Application for Licence Amendment

Licence Number	L4328/1989/10
Licence Holder	MARBL Lithium Operations Pty Ltd
ACN	637 077 608
File Number	INS-0001138 APP-0029828
Premises	Wodgina Lithium Project M45/49, M45/50-I, M45/254, M45/353, M45/365-I, M45/381, M45/382, M45/383-I, M45/886, M45/887-I, M45/888, M45/950-I, M45/923-I, M45/924-I, M45/925-I, M45/949, M45/1188-I, M45/1252-I, G45/290, G45/291, G45/321 and L45/443 MARBLE BAR WA 6760 As depicted in Schedule 1 of the Revised Licence
Date of Report	31 October 2025
Decision	Revised licence granted

Figure 1: EWL1 and EWL2 deposition footprints.

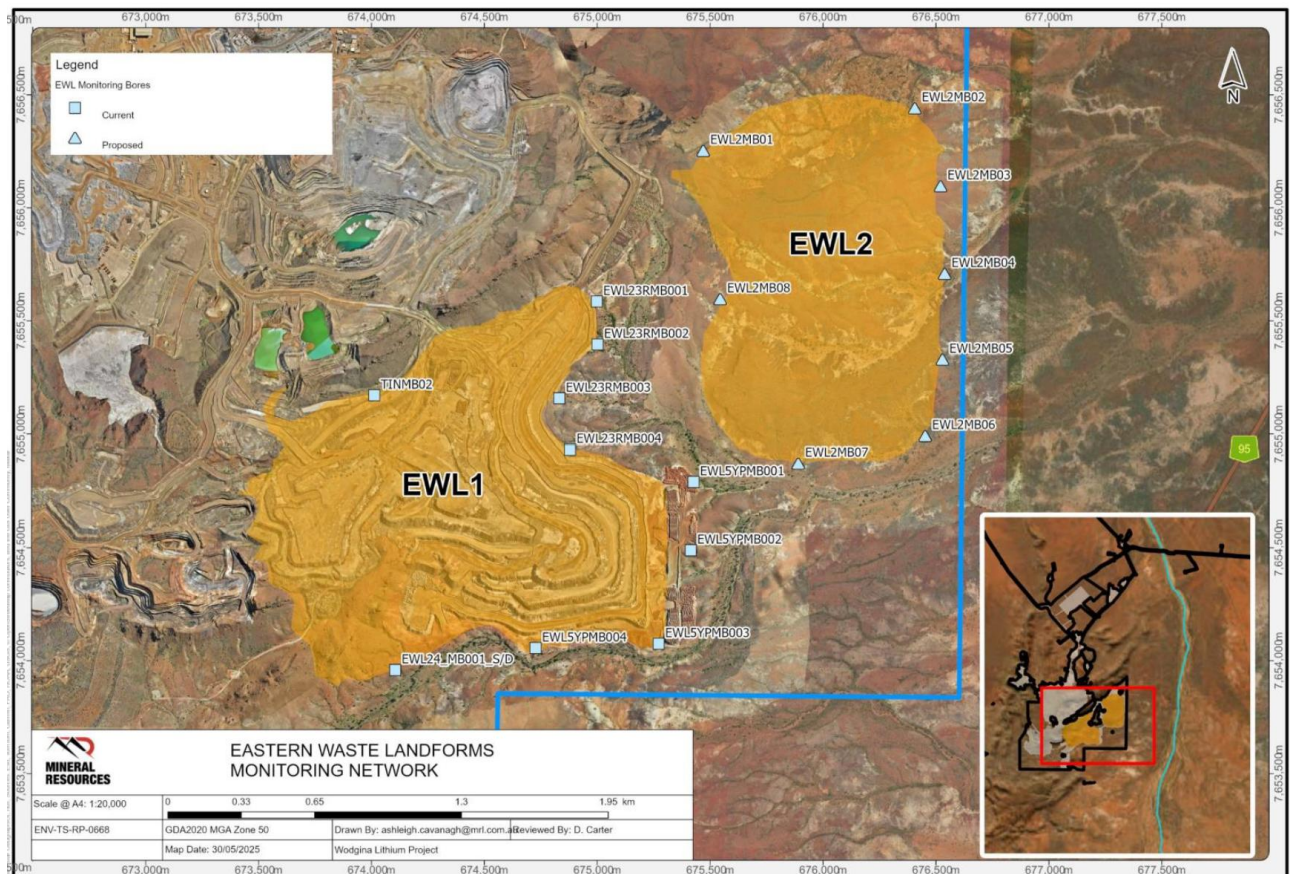
- Update Condition 3 Table 2 to include EWL1 and EWL2 facilities with the following additional process limits and /or specifications:
 - Increase the area of deposition from 209.2 ha to 363.8 ha (EWL1:208.8 ha, EWL2:155.2 ha).
- Add the following process limits and /or specifications to Condition 3 Table 2:
 - Dry stack tailings to be deposited in the EWL1 will not be placed within the approved cover system of the final embankments or underneath an embankment slope.
 - A compacted base layer of non-acid forming (NAF) material will be placed prior to deposition into the landforms in a progressive approach, with depths modelled based on natural ground conditions and potential hydrological ingress to the landform.
 - Landform designs require a NAF material cover layer and specific cover system requirements (e.g. rock armouring, growth media) to reduce oxygen ingress.

See Figure 1 for footprint areas of EWL1 and EWL2.

- Dry Stack Tailings Deposition into EWL2**
 Approval has been granted to increase the deposition area for co-mingled tailings from 209.2 ha to 363.8 ha.
